# Office Action Summary

10/521,387

LUTTMANN ET AL.

### DETAILED ACTION

**Figure 1: Automated production of recombinant proteins (Cornelissen et al.)**

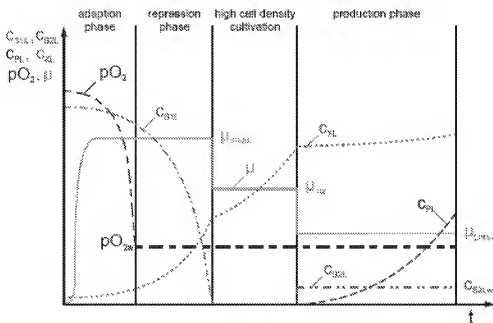
process is conducted in a sequential and integrated manner, but does imply that the process steps happen in a specific sequence. Referring to Figure 1 of the OA, each phase of production leads to another phase which strongly implies that the production of recombinant DNA as taught by Cornelissen is sequential. Further, the automation of this process as shown in Figure 4 of Cornelissen shows that each part of the process is integrated or coupled and are part of the whole process (page 6 section 8 paragraph 1). Regarding the method of producing biotechnologically valuable products as in claim 5, Cornelissen teaches that the cells adapt to the medium and that the cells are propagated at a constant growth rate,  $\mu$ , for the batch phase (page 3 sections 3 and 4, Fig. 2) and for claim 6 Cornelissen teaches the step of using an induction substance such as methanol during the production phase (page. 3 section 3 paragraph3) . For claim 7, Cornelissen teaches the step of using a flow diffusion analysis (FDA) to regulate a second feed receptacle (page 3 section 4, Fig. 3). With regards to claim 8, Cornelissen teaches that the product is harvested from the bioreactor by using a cross-flow filtration step (page 1 section 2 paragraph 5), but does not specify that the product is harvested cell-free. However, since the cross-flow filtration step filters out the recombinant DNA produced within the bioreactor, it is an intrinsic property of the product that it would be cell-free.

20. For claim 15, Cornelissen does not specify that the process is conducted in a continuous and integrated manner, but does imply that the process is continuous and integrated. Referring to Figure 1 of the OA, each phase of production leads to another phase which strongly implies that the production of recombinant DNA as taught by Cornelissen is continuous. Further, the automation of this process as shown in Figure 4
